S E R V I C E N O T E

87510A Gain-Phase Analyzer

Modification to prevent the 87510A from a CRT failure which leads to no picture on the display

Figure 1. Cable Clamp Location

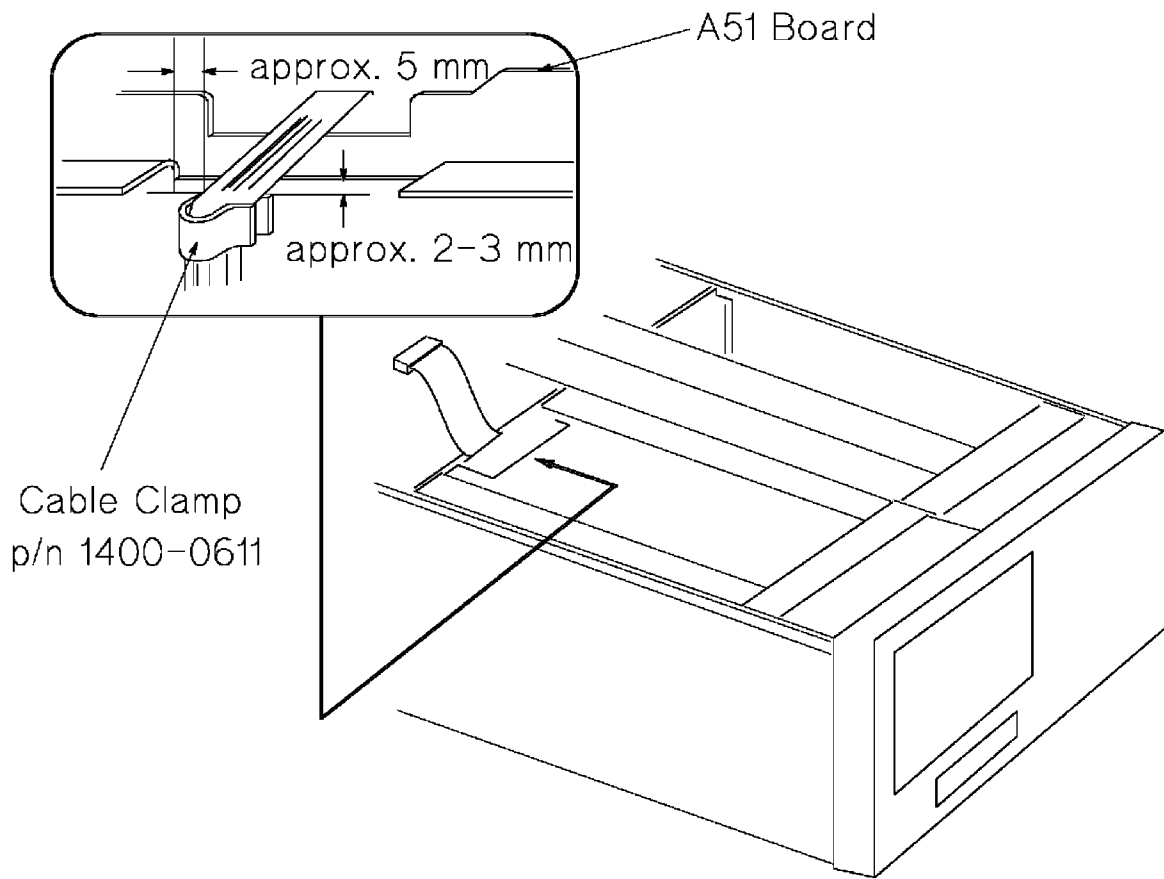
The flatcable (p/n 87510-61646) might be pinched and cut off by the edges of the shield plate (p/n 87510-64915) and the A51 GSP board because the flatcable is not fastened in place.

If the flatcable is crushed then replace the flatcable with a new one. Fix the cable to the CRT assembly with a cable clamp regardless of the degree of flatcable deterioration.

1. Disconnect the power cable from the 87510A.
2. Remove the top cover from the 87510A.
3. Remove the twelve screws which fasten the shield plate over the A51 board and the CRT, and remove the shield plate.
4. Check carefully if the flatcable (CRT -A51) is crushed by the shield plate and A51 board. If it is crushed or damaged then replace it with a new one (p/n 87510-61646).
5. Regardless of the degree of flatcable degradation, fasten the flatcable in place with the Cable Clamp (p/n 1400-0611) so that the edges of the shield plate (p/n 87510-64915) and the A51 board do not pinch the flatcable. (Refer to Figure 1).
6. Install the shield plate over the A51 board and the CRT.
7. Turn the 87510A ON and confirm the "POWER ON TEST FAILED" message is NOT displayed.
8. Turn the 87510A OFF.
9. Reinstall the top cover on the 87510A.
